**DELAWARE VETERANS MEMORIAL CEMETERY
MILLSBORO, DELAWARE**

DE-13-21

ADDENDUM NO. 1

June 21, 2016

GI002-SK-2

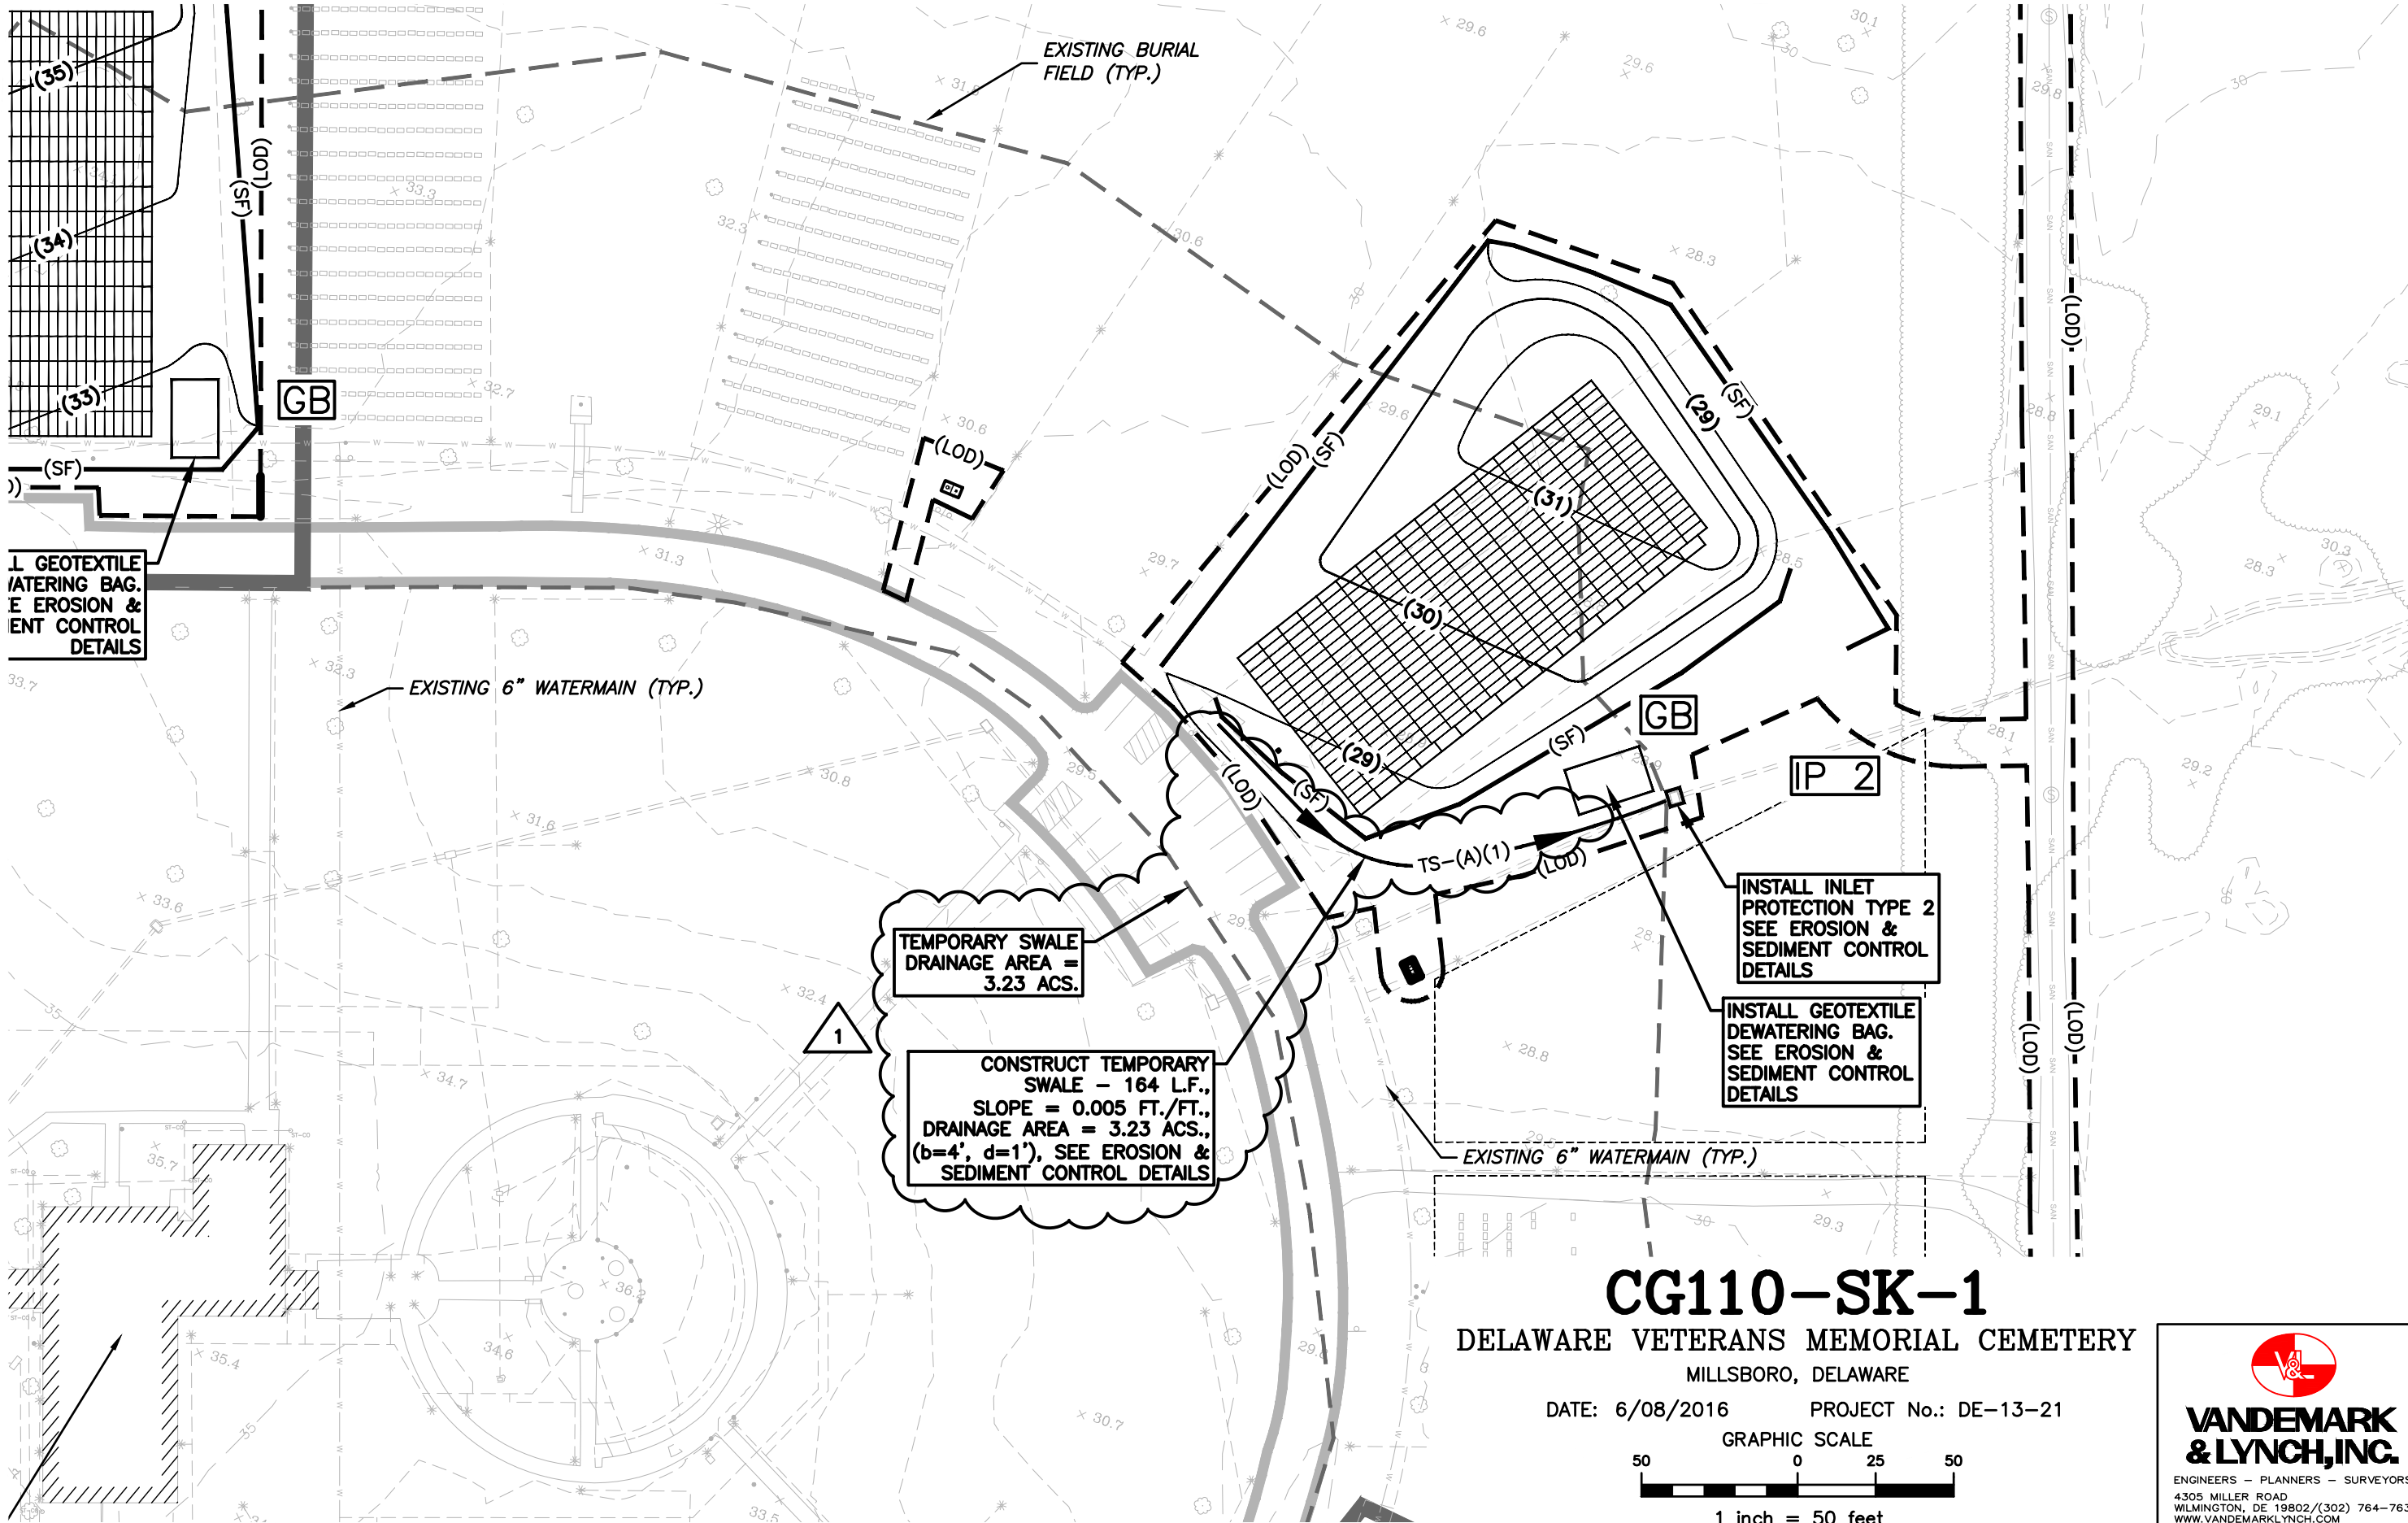
1. GI002-SK-1: Added Temporary Swale to and removed Diversion Swale from legend.
2. GI002-SK-2: Revised stabilization matting product recommendation to North American Green S150.

7. EROSION CONTROL MATTING IS REQUIRED IN OPEN CHANNELS AND ON SLOPES OF 3H:1V OR STEEPER. MATTING SHALL BE "NORTH AMERICAN GREEN S150" OR AN EQUAL APPROVED BY DNREC, SEDIMENT AND STORMWATER PROGRAM.

CG110-SK-1

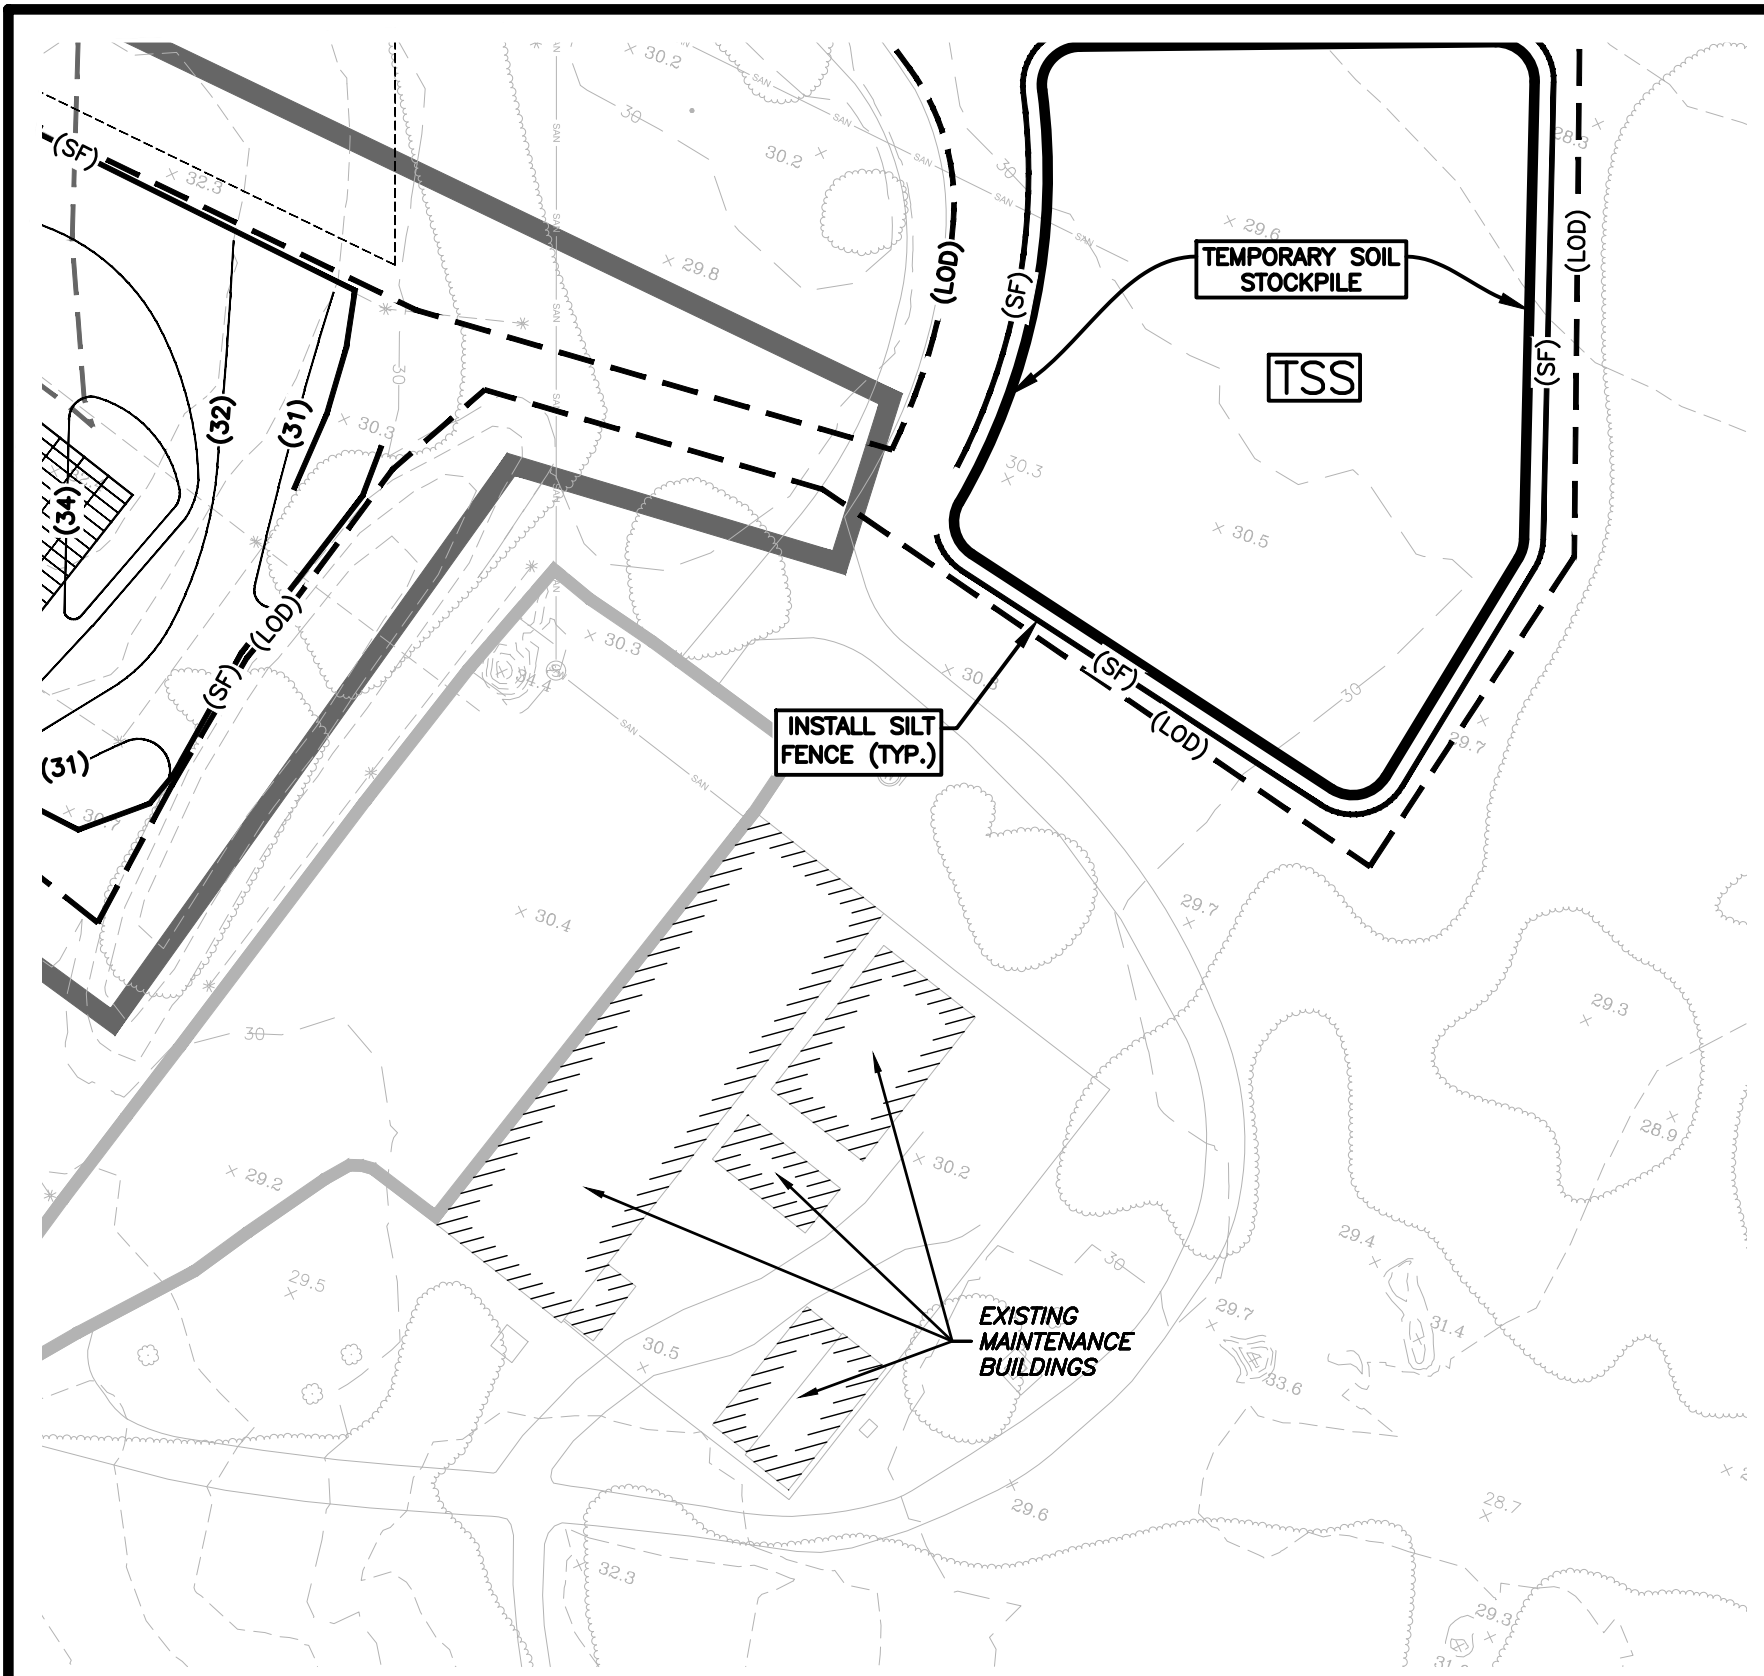
3. CG110-SK-1: Changed Diversion Swale callout and symbol to Temporary Swale. Added drainage area label for temporary swale.
4. CG110-SK-2: Revised Erosion & Sediment Control Legend reference of Diversion Swale to Temporary Swale. Added drainage area line type reference.

CONSTRUCT TEMPORARY
SWALE - 164 L.F.,
SLOPE = 0.005 FT./FT.,
DRAINAGE AREA = 3.23 ACS.,
(b=4', d=1'), SEE EROSION &
SEDIMENT CONTROL DETAILS

CG501-SK-1
DELAWARE VETERANS MEMORIAL CEMETERY
MILLSBORO, DELAWARE

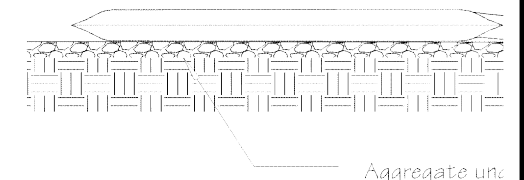
5. CG501-SK-1: Removed Diversion Swale details. Added Temporary Swale details.
6. CG502-SK-1: Added boxes around recommended temporary and permanent seed mixes.

CU201-SK-1

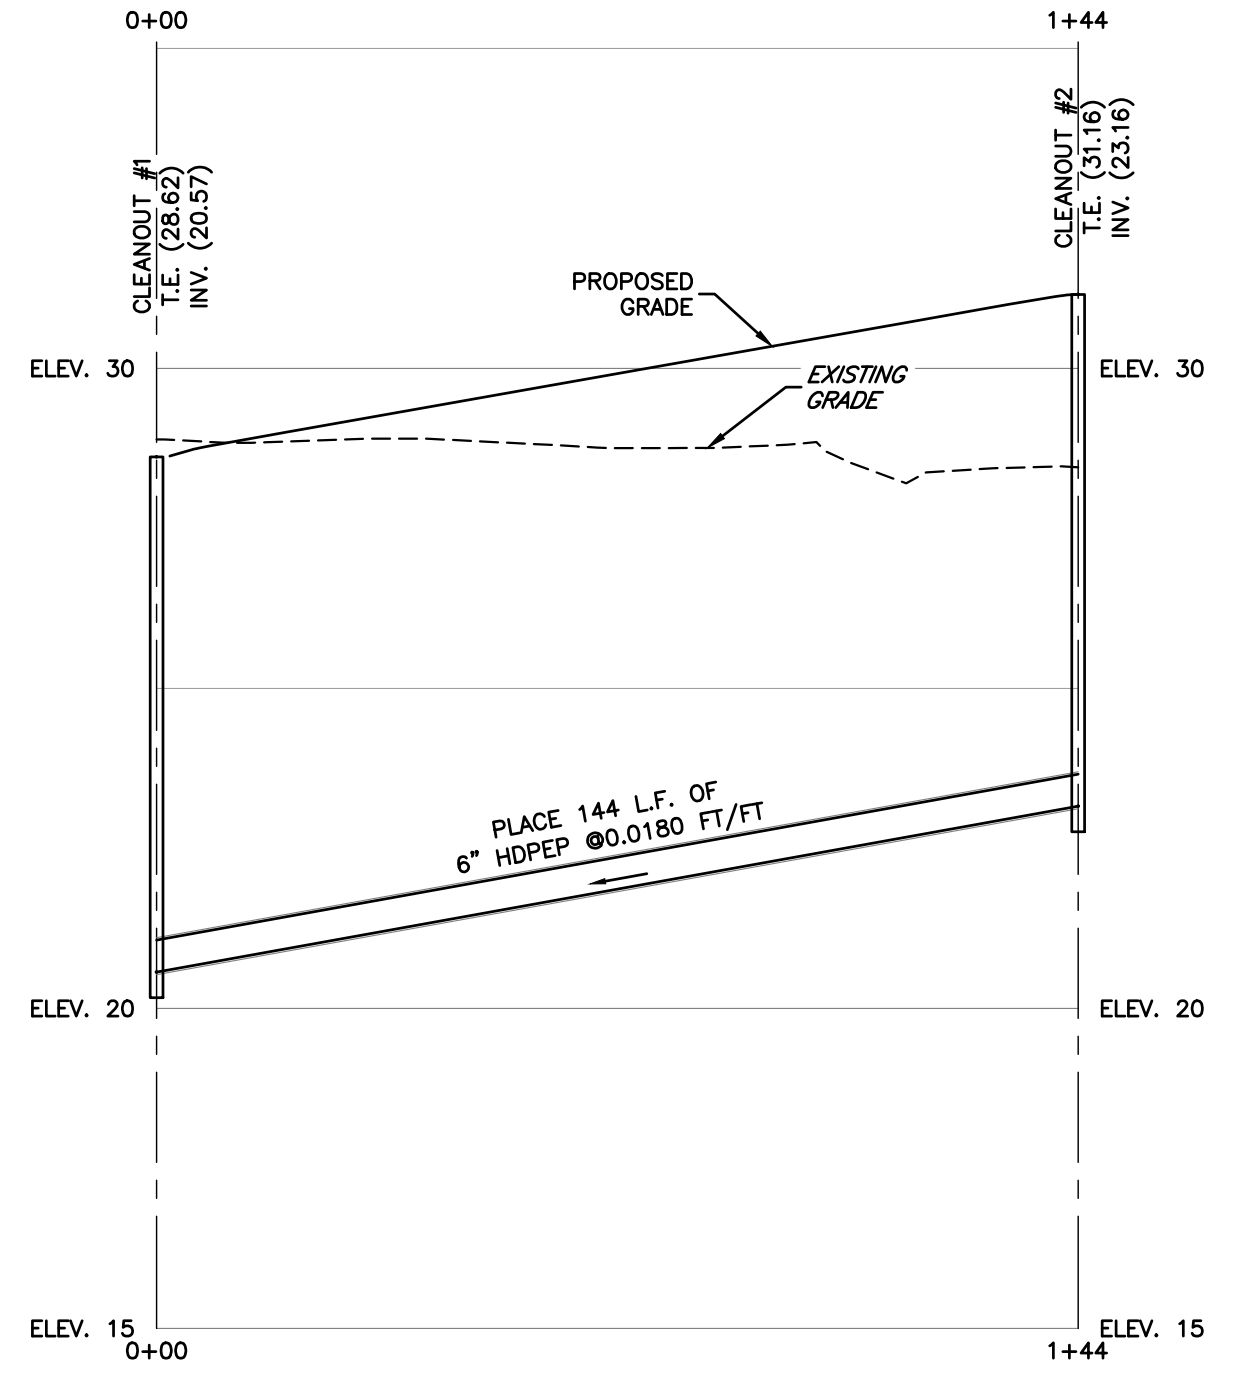
7. CU201-SK-1: Updated profile title to reference storm cleanout labels depicted in the profile.
8. LI103-SK-1: Added note requiring contractor to locate isolation gate valve.

PROFILE
STORM CO#6 TO CO#5
 HOR. SCALE= 1" : 30'
 VER. SCALE= 1" : 3'

PROFILE
STORM CO#2 TO CO#1
